PROJECT NUMBER: SP2024-037
PROJECT NAME: Amended Site Plan for 5901 Horizon Road
SITE ADDRESS/LOCATIONS: 5901 HORIZON RD

SUBJECT: SP2024-037; *Administrative Site Plan for Garages of America*

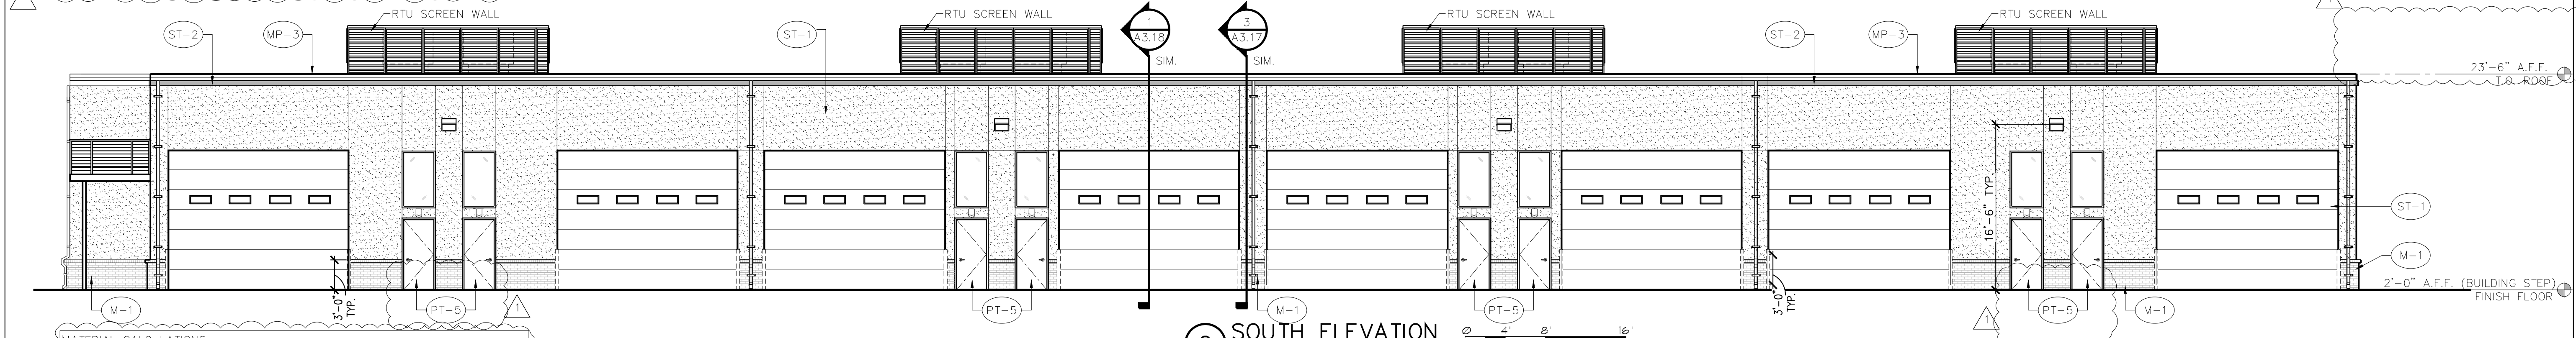
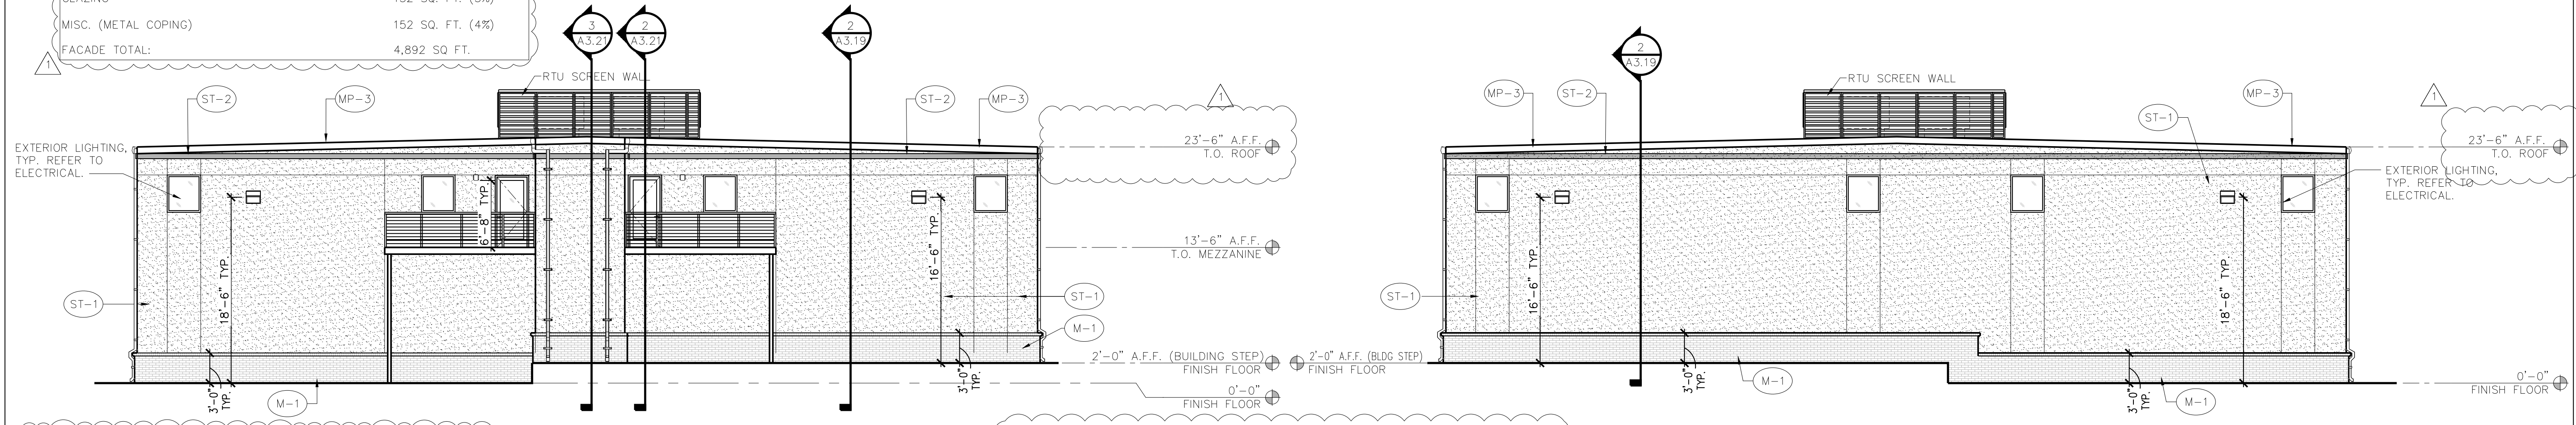
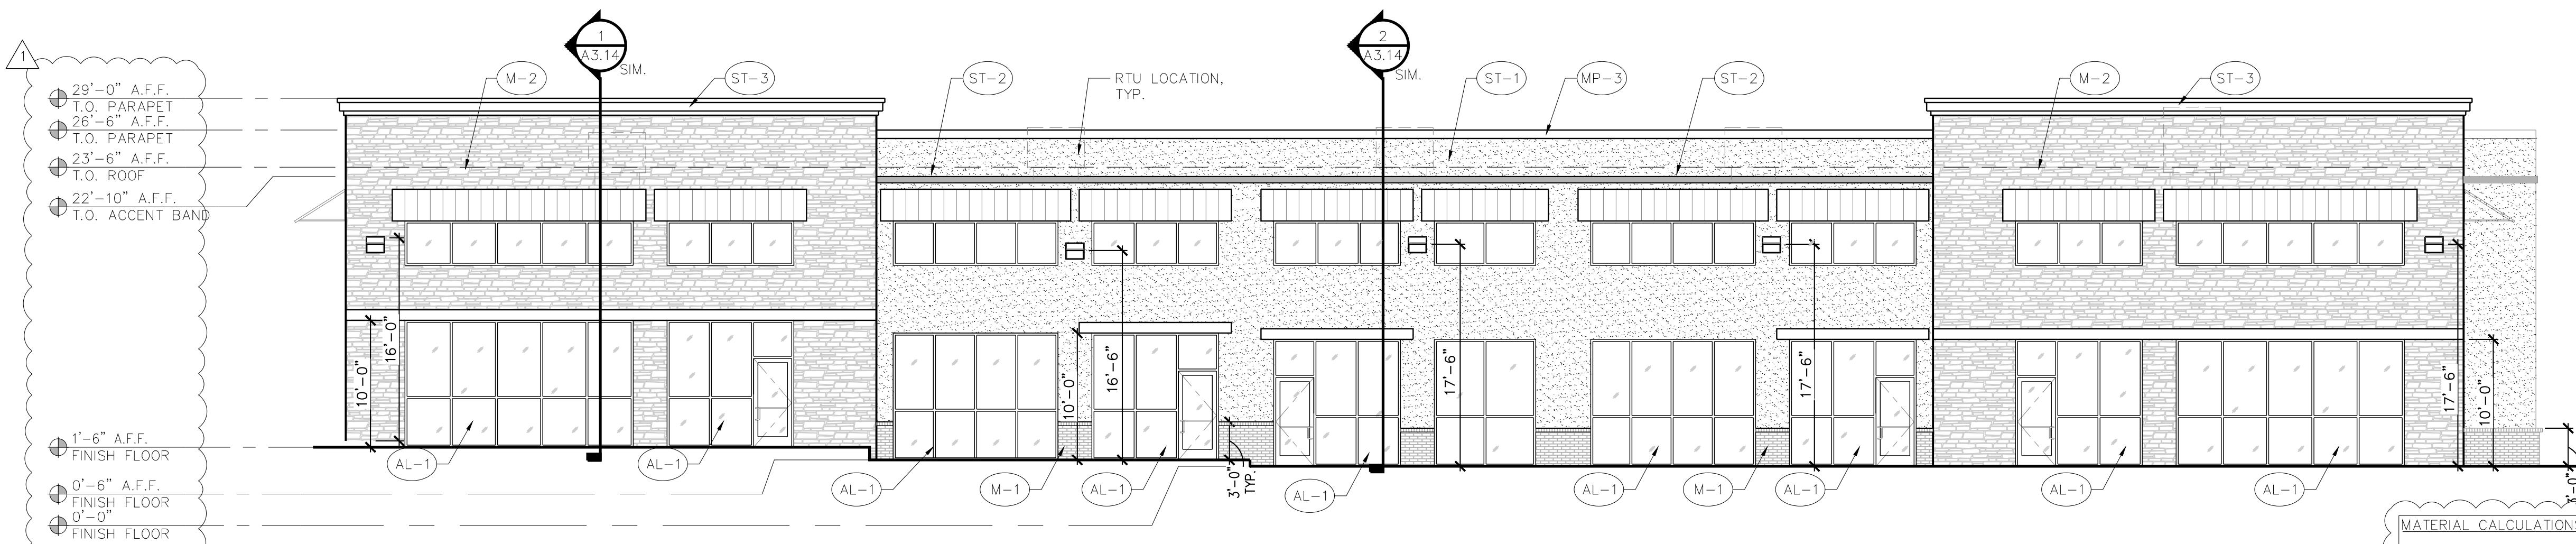
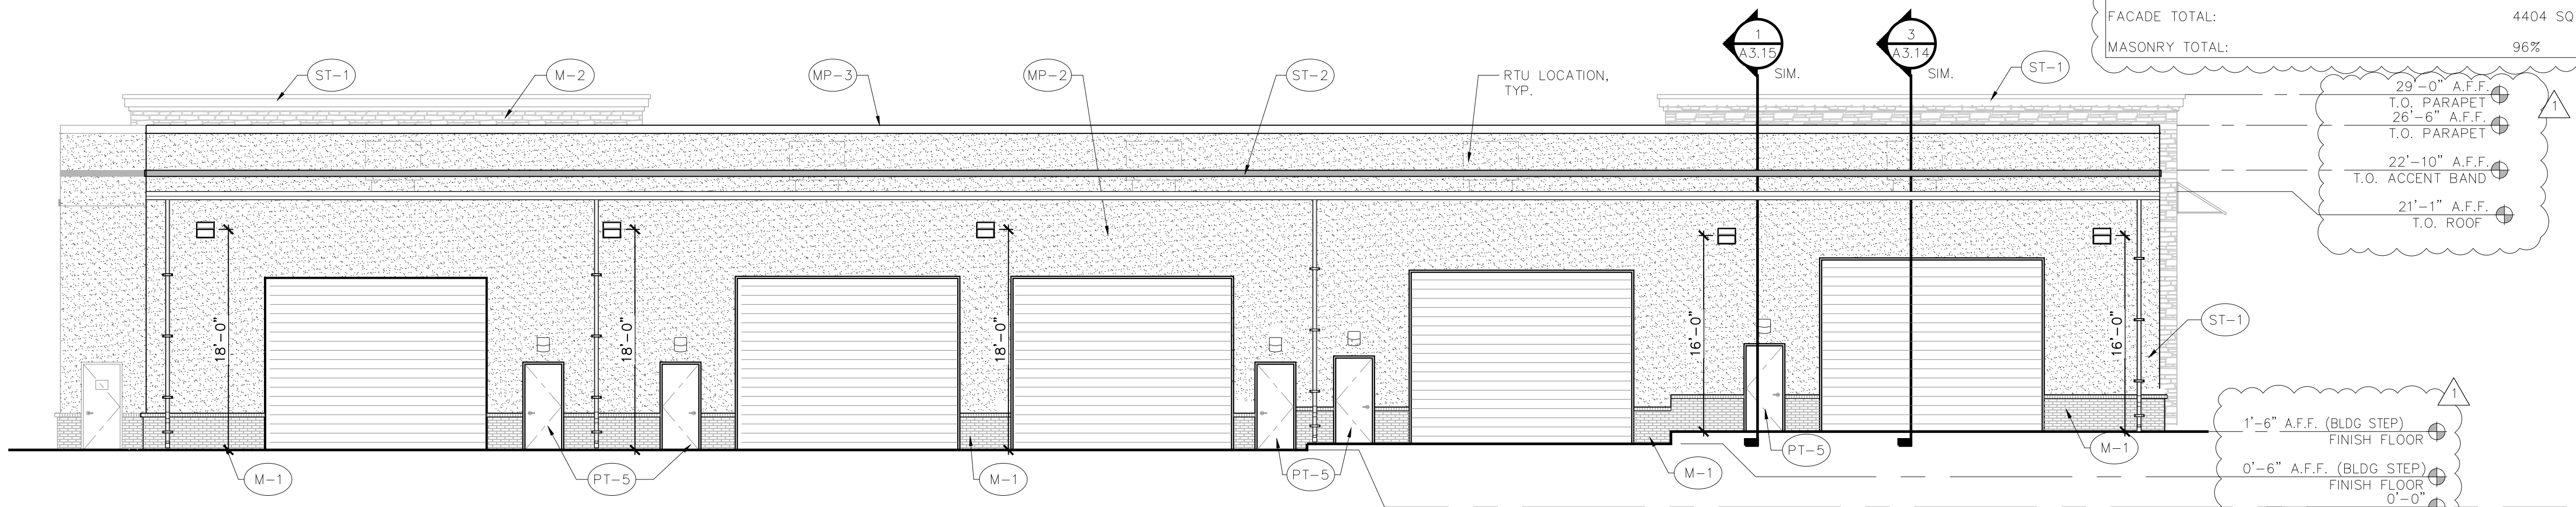
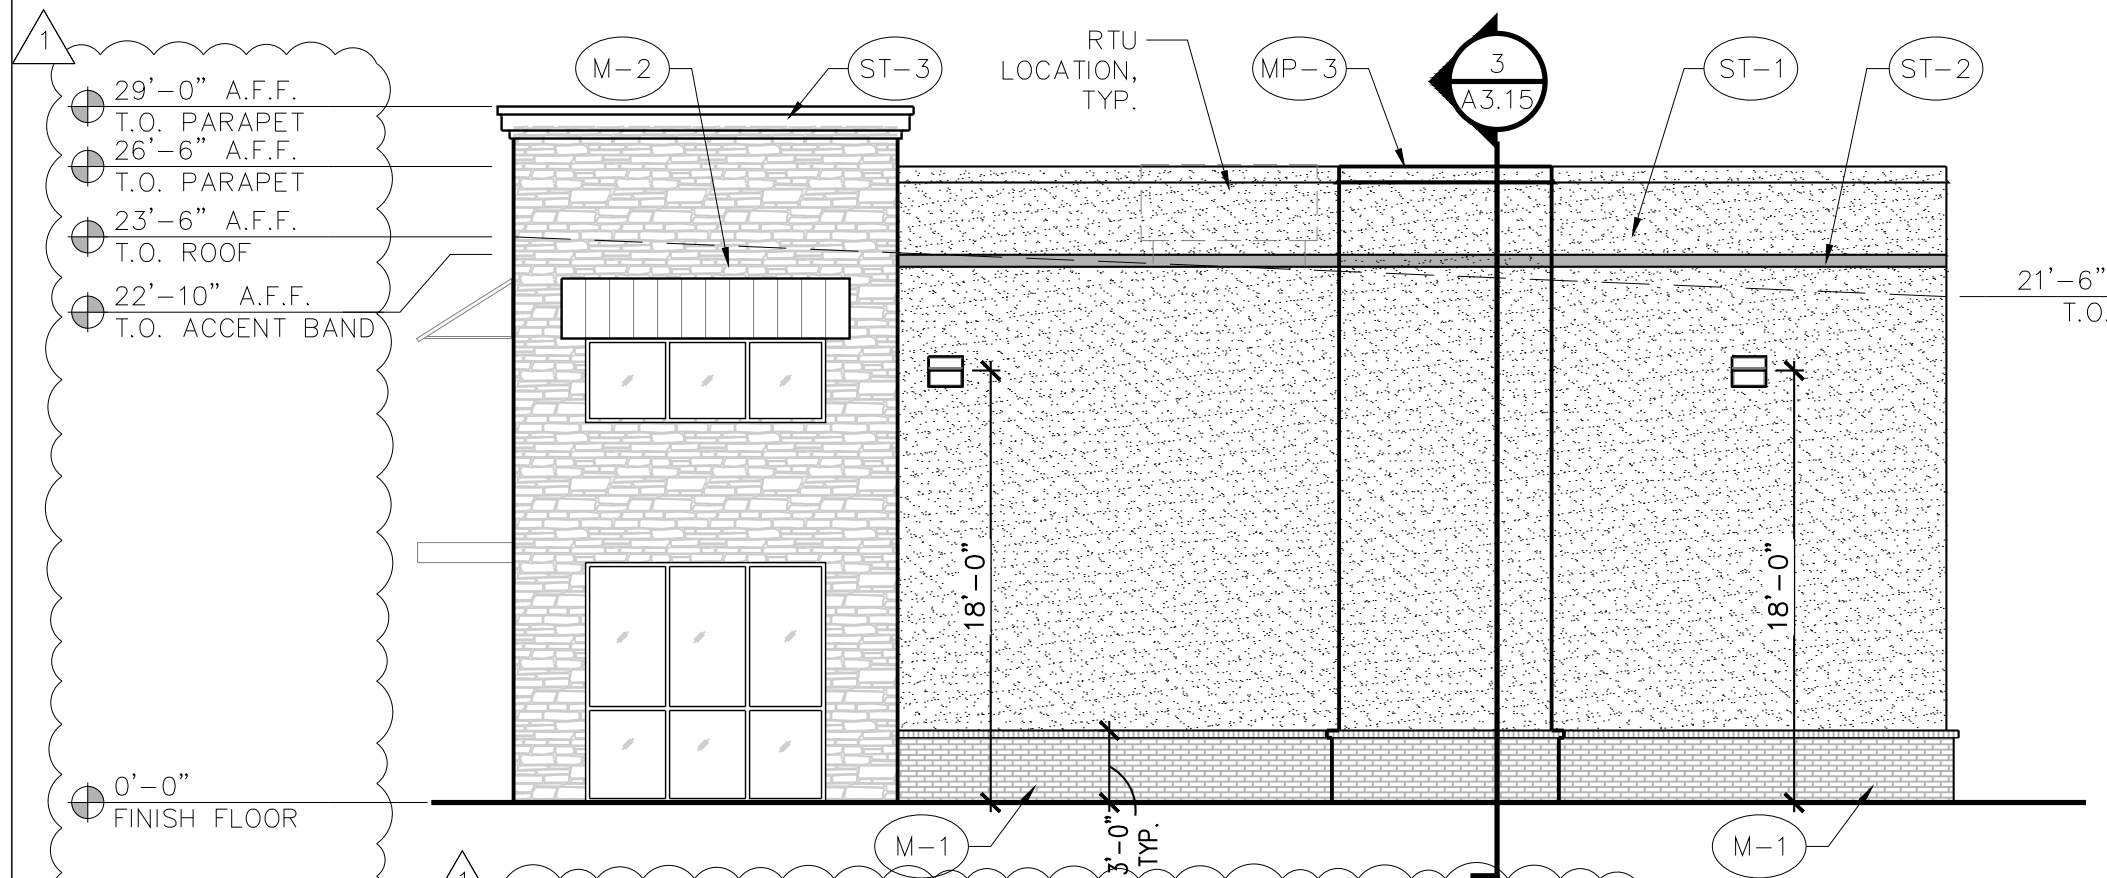
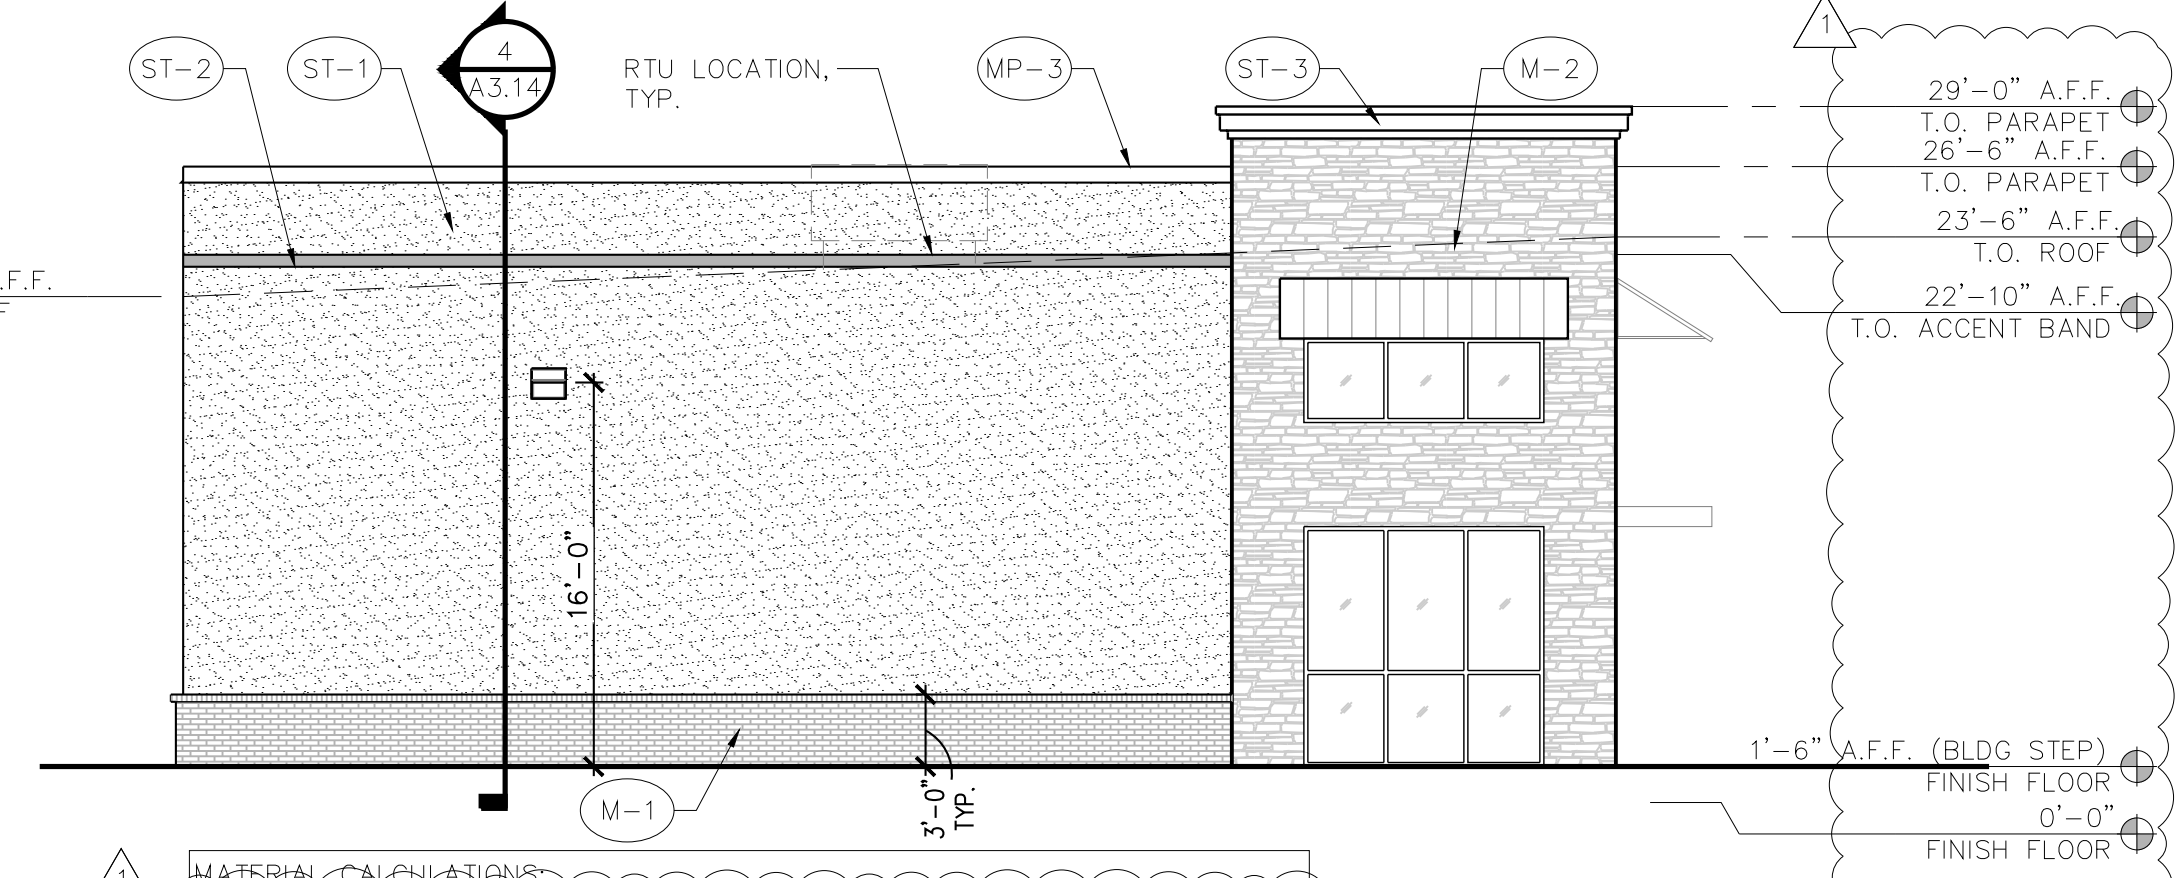
- (1) Please provide Building 1 with the Phase 1 building elevations; Building B was included twice. (Subsection 06.02, of Article 05)
- (2) Please remove the doors and windows from the material percentages. Staff needs to verify that the material requirements are still met. (Subsection 04.01, of Article 05)
- (3) Please indicate the roofing material on the pitched roof buildings. If metal, they must be standing seam; include this on the material table for each building. (Subsection 04.01, of Article 05)
